Trinity Grammar School Redevelopment (SSD-10371)
Request for Additional Information

I refer to Response to Submissions (RtS) for the Trinity Grammar School Redevelopment (SSD-10371). After careful consideration, the Department is requesting that you provide additional information as follows:

Figure 1: VP15B View impact assessment (Appendix 11, p53)
View from first floor bedroom standing at window of
157 Victoria Street (50mm lens used for emphasis)

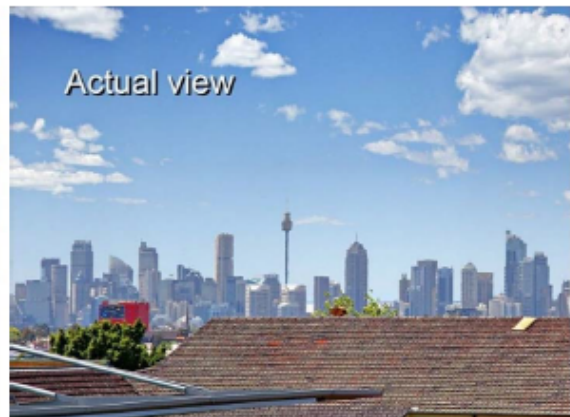
The RtS includes a small reduction in height, however no assessment of view impacts has been provided. A public submission (extract attached below) demonstrates adjoining premises enjoy city skyline views over the site. This has not been addressed in the RtS. Consideration should be given to the view impacts of the proposal having regard to the Planning Principle in *Tenacity Consulting v Warringah 2004 NSWLEC 140*.

The View Impact Assessment (Appendix 11, Page 22) stated that there “would be no loss of view of items identified as valued, in Step 1 of Tenacity”. Sufficient evidence to demonstrate the accuracy of this statement was not provided.

There are obvious discrepancies in the two photos taken from the exact same location (first floor of 157 Victoria Street). It is significant that VP15B is the only photo in the Visual Impact Assessment that required a “50mm lens used for emphasis” and photomontage and view in place data sheets were omitted from the Appendix.
